June 3, 2024

**Re: General Atomics Office
14820 Central SE
Traffic Circulation Layout
Engineer's/Architect's Stamp 5-24-2024 (L23D011A)**

Based upon the information provided in your submittal received 5-29-2024, the above referenced plan cannot be approved for Building Permit until the following comments are addressed:

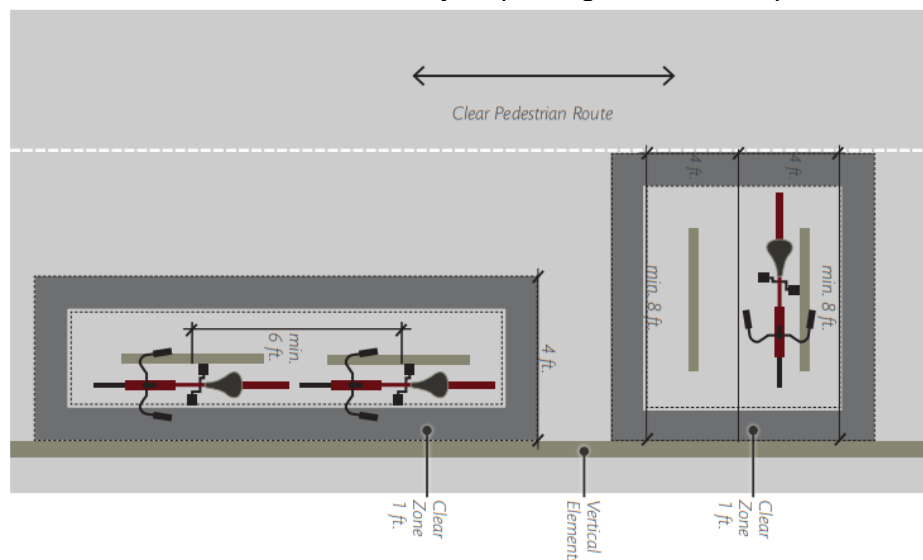
6. The ADA accessible spaces must include an access aisle. Van accessible aisles should be 8ft wide; all others should be 5ft wide.

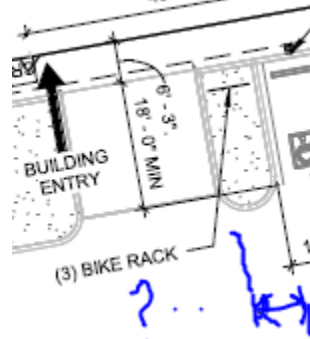
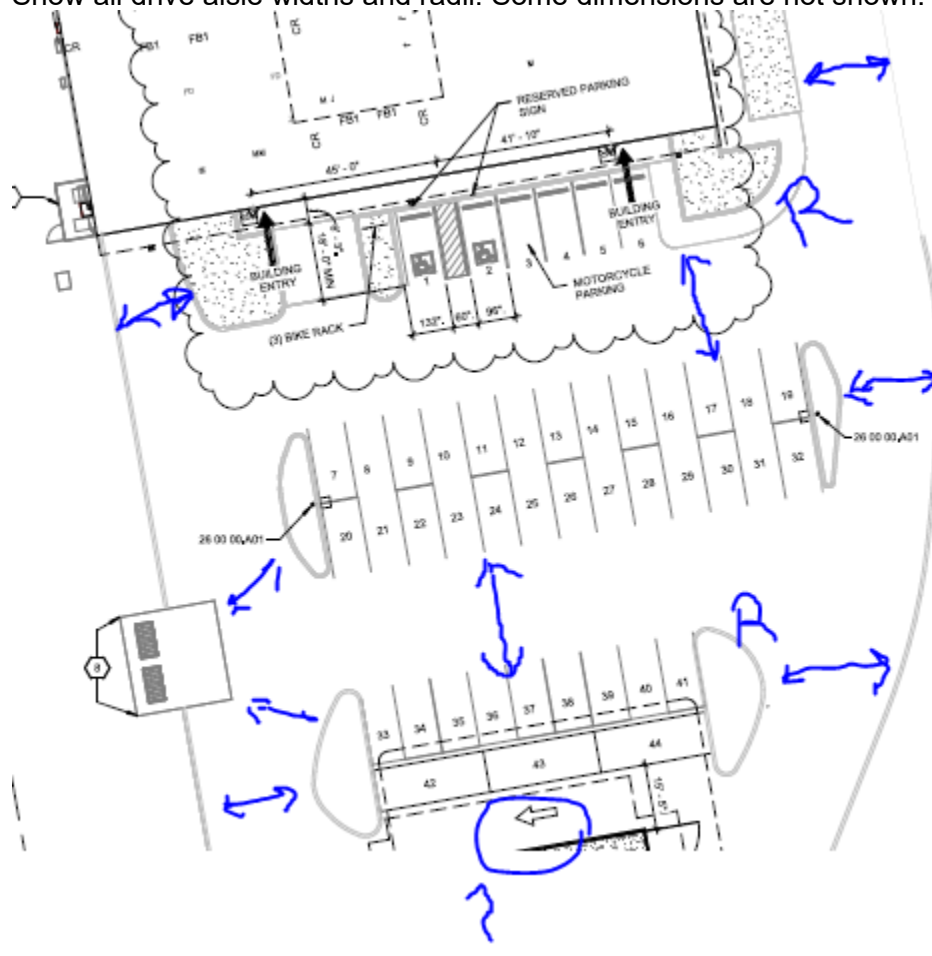
7. ADA curb ramps must be updated to current standards and have truncated domes installed.
8. Motorcycle parking spaces shall be designated by its own conspicuously posted upright sign, either free-standing or wall mounted per the zoning code.
9. All bicycle racks shall be designed according to the following guidelines:
 - a. The rack shall be a minimum 30 inches tall and 18 inches wide. Show your details.
 - b. The bicycle frame shall be supported horizontally at two or more places. Comb/toaster racks are not allowed.
 - c. The rack allows varying bicycle frame sizes and styles to be attached.
10. Bicycle racks shall be sturdy and anchored to a concrete pad.
11. A 1-foot clear zone around the bicycle parking stall shall be provided.

12. Bicycle parking spaces shall be at least 6 feet long and 2 feet wide.

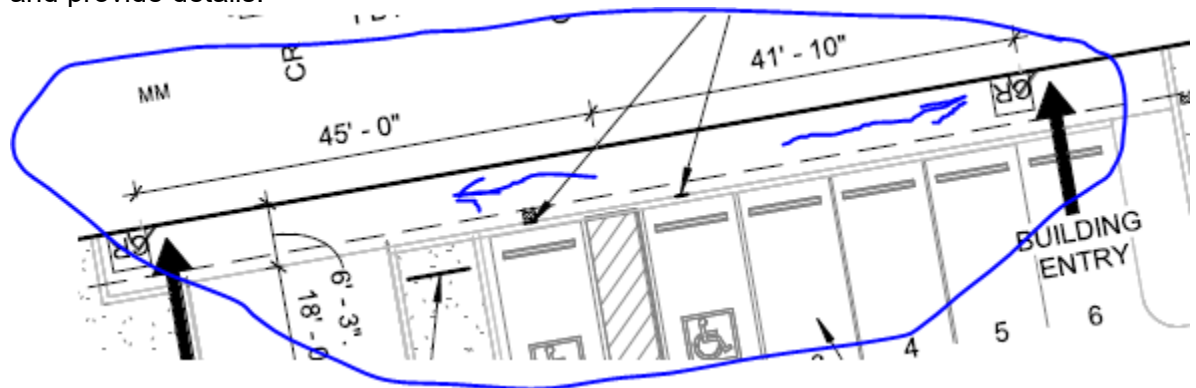
14. The minimum drive aisle dimensions are shown below

Minimum Drive Aisle Width
Two Way Traffic	22'

Main Circulation Road	24'
Fire Lane	20'
